January 21, 2020  
**Notice of Inspection**  
DAM #D183010

RE: Harvey Lake Dam #D183010, Northwood  
Hazard Classification: Non-menace

Harvey Lake Dam field sketch JDF 10/22/19.

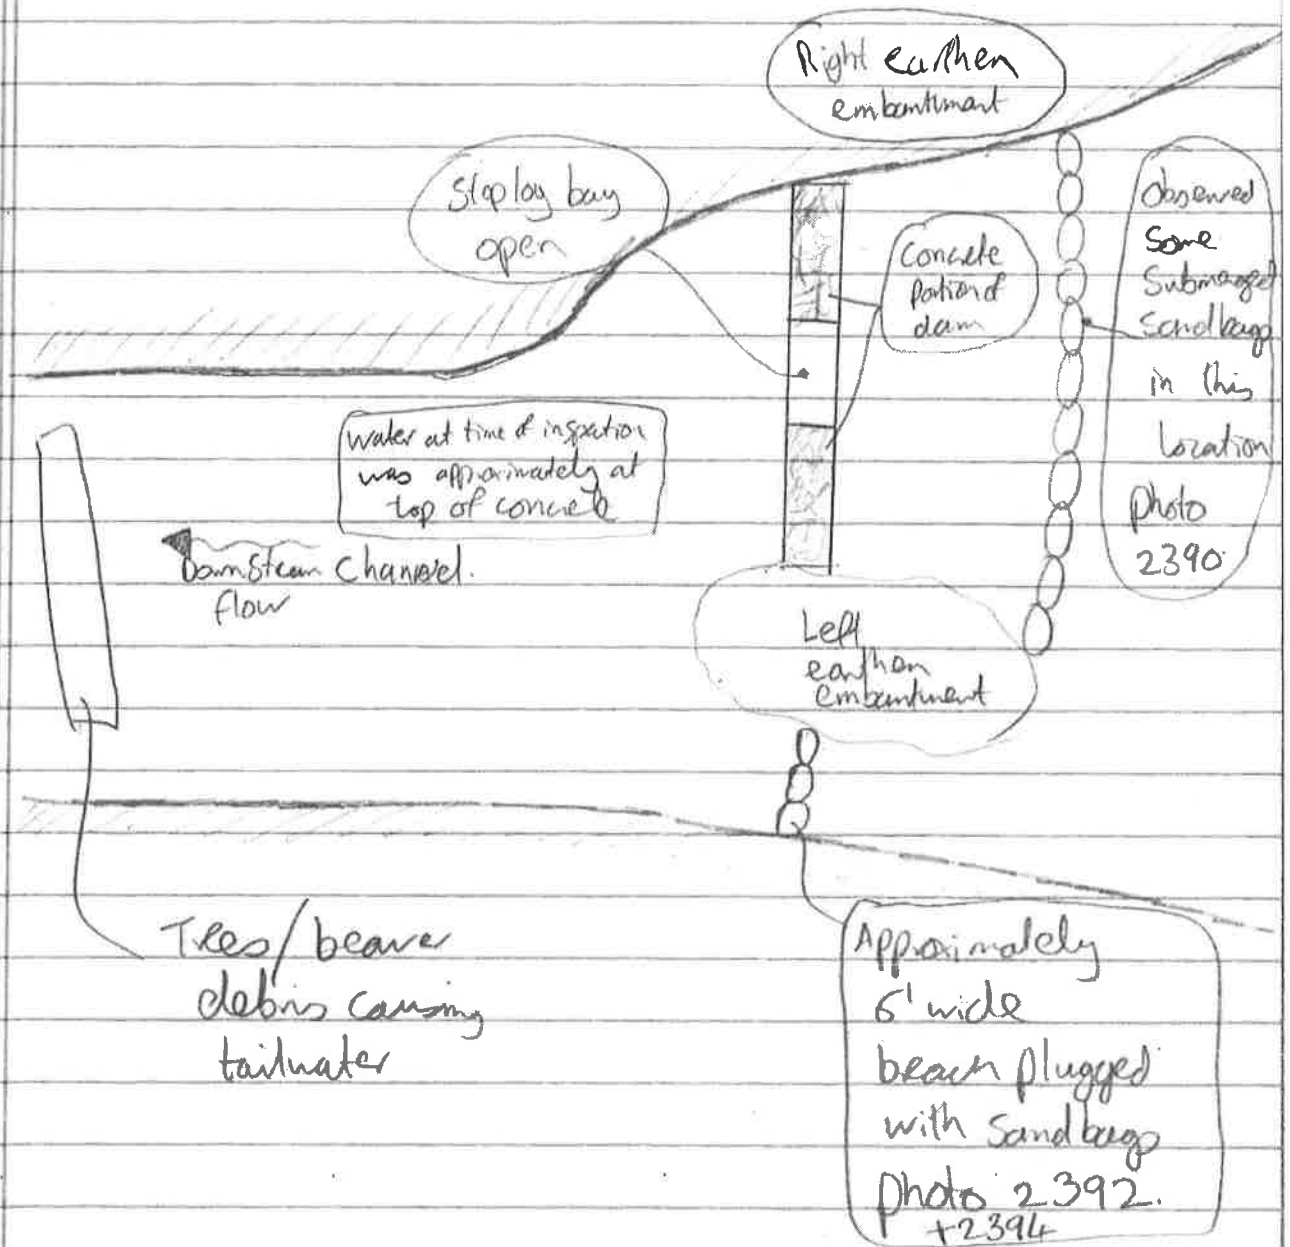
3. NHDES observed an approximately 6' wide breach that had been plugged up with sandbags on the left side of the dam located approximately 10' left of the concrete spillway (Photo 2392) – See sketch attached. Given that the sandbags appear to have been in-place for considerable time, NHDES will not require them to be removed; however, placement of further sandbags will constitute a wetlands violation and any further attempts to repair/reconstruct the breached area will require permits from both NHDES's Dam Safety and Wetlands programs. Dam reconstruction is defined in RSA 482:2X which has been reproduced below. Please note, that per the RSA definition, other modifications to the dam could also require a Reconstruction permit.

4. Some submerged sandbags were observed approximately 15' upstream of the concrete portion of the dam when it appears that someone has attempted to construct a sandbag dam (Photo 2390) – See sketch attached. Similar to the comment above, given that the sandbags appear to have been in-place for considerable time, NHDES will not require them to be removed; however, placement of further sandbags will constitute a wetlands violation; and
